Change Order Nbr:

005

Change Order Description: Removal of unsuitable soils

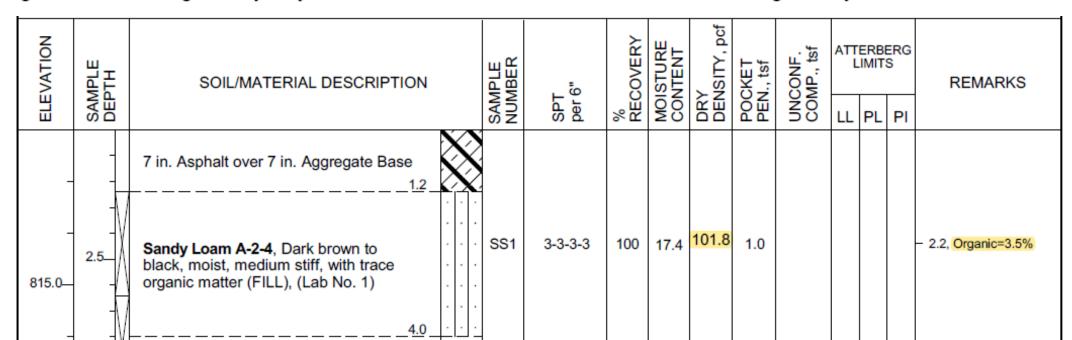
During construction of Phase 2 of this project (North lane) black unsuitable soils were encountered below subgrade elevation. These unsuitable soils varied in depths from 1 foot to 2.5 feet. The unsuitable soil was removed as recommended in the geotechnical report of this contract. Page 5 of the geotechnical report is included in the attachments of this change order. The quantities and calculations for Phase 2 are included in attachments. A quantity has been estimated for Phase 3 pavement areas and sidewalk areas and are also attached. A summary page with the total quantity is also attached. The contractor is not requesting any additional time for this work.

PreBid Review: All borings depict a layer of concern

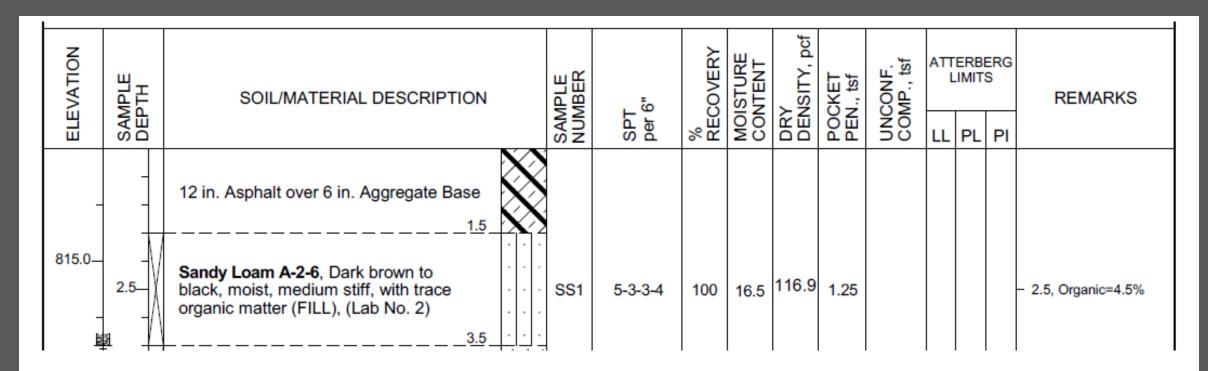
All borings then revealed old fill materials consisting of dark brown to black sandy loam (A-2-4 or A-2-6) to depths ranging from about 3.5 ft to 5 ft below the ground surface. Moisture and organic contents of the samples from this zone were as high as about 19% and 4%, respectively.

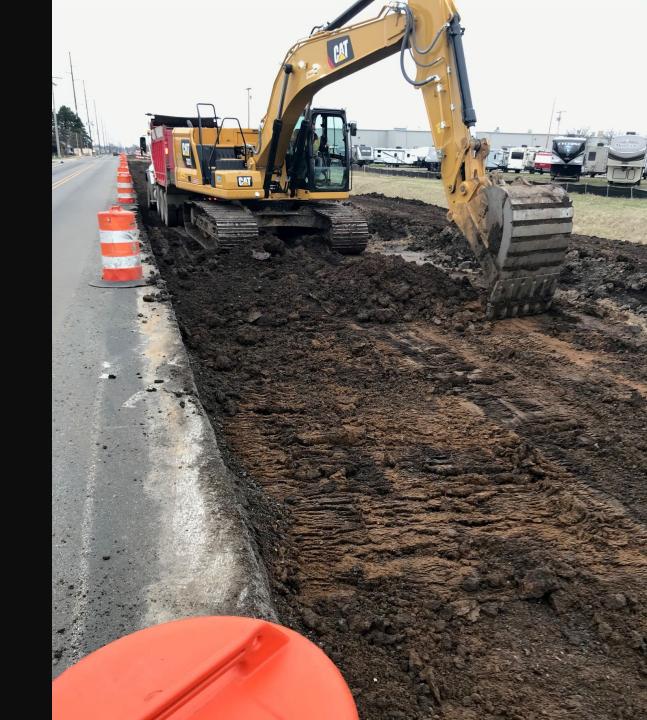
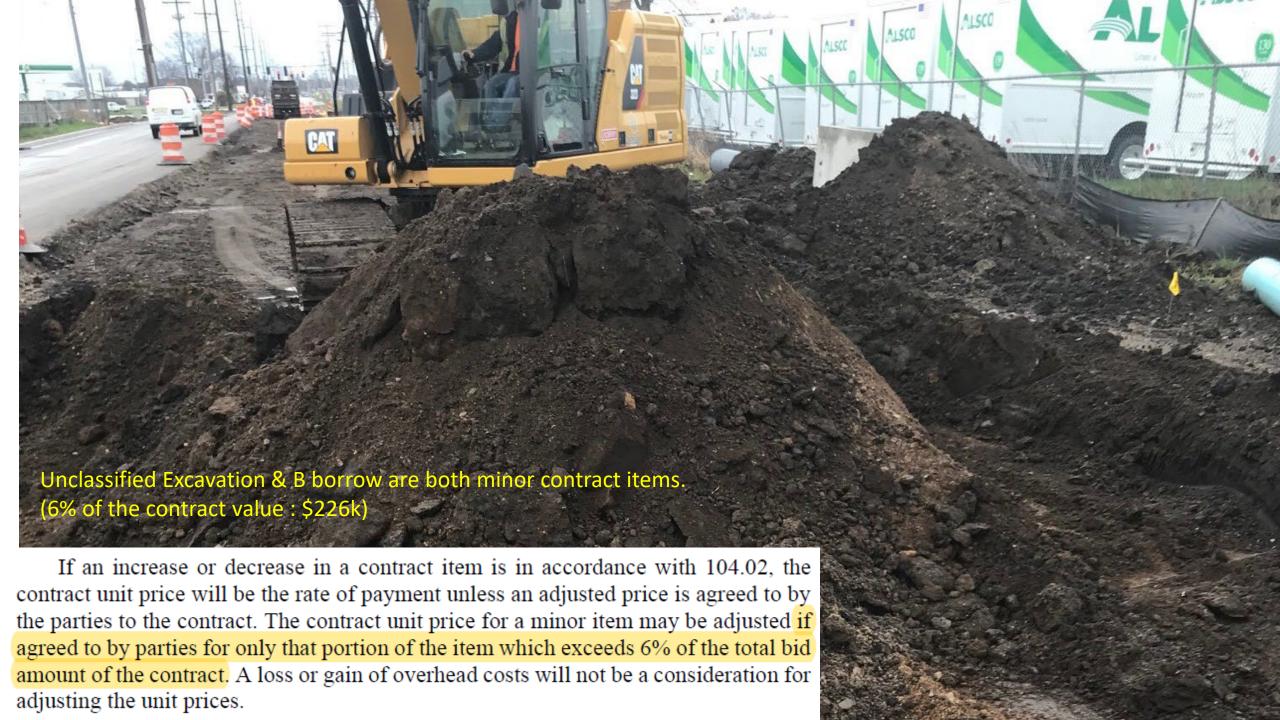
- Modify the subgrade treatment from the bid Type IB @ \$7.75/syd to Type IC the average unit cost is about \$24/syd
 - (\$24.12 \$7.75) x 27,337syd = \$448k
 - Cost not feasible and we would still need additional undercutting

- Performing 2 lifts of type IB not feasible
 - Handling upper lift would require bid item Common Excavation at \$25/syd
 - Utilities
